UNITED STATES PATENT AND TRADEMARK OFFICE

APPLICATION NO.	FILING DATE	FIRST NAMED INVENTOR	ATTORNEY DOCKET NO.	CONFIRMATION NO.
10/625,300	07/22/2003	Nicholas Atkins	ATKN101CIP	7878
21658	7590	09/29/2005	EXAMINER	
DYKAS, SHAVER & NIPPER, LLP			NGUYEN, TUAN N	
P.O. BOX 877			ART UNIT	PAPER NUMBER
BOISE, ID 83701-0877			3751

Office Action Summary	Application No.	Applicant(s)	
	10/625,300	ATKINS ET AL.	
	Examiner Tuan N. Nguyen	Art Unit 3751

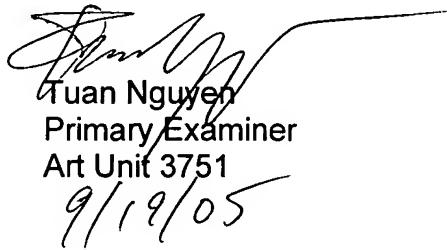
In regard to claims 14 and 15, although the Atkins lip does not include ridges thereon extending substantially circumferentially around the lip as claimed, attention is directed to Fig. 17 of Atkins, which discloses an analogous seal which further includes a lip (167) having ridges (define by 165) thereon extending substantially circumferentially around the lip to increase the sealing effect with the abutting member (see page 18, line 26 et seq.). Therefore, it would have been obvious to one of ordinary skill in the art at the time the invention was made to employ, on the seal of Fig. 6 of Atkins, ridges as, for example, taught by Fig. 17 of Atkins in order to increase the sealing effect with the abutting member.
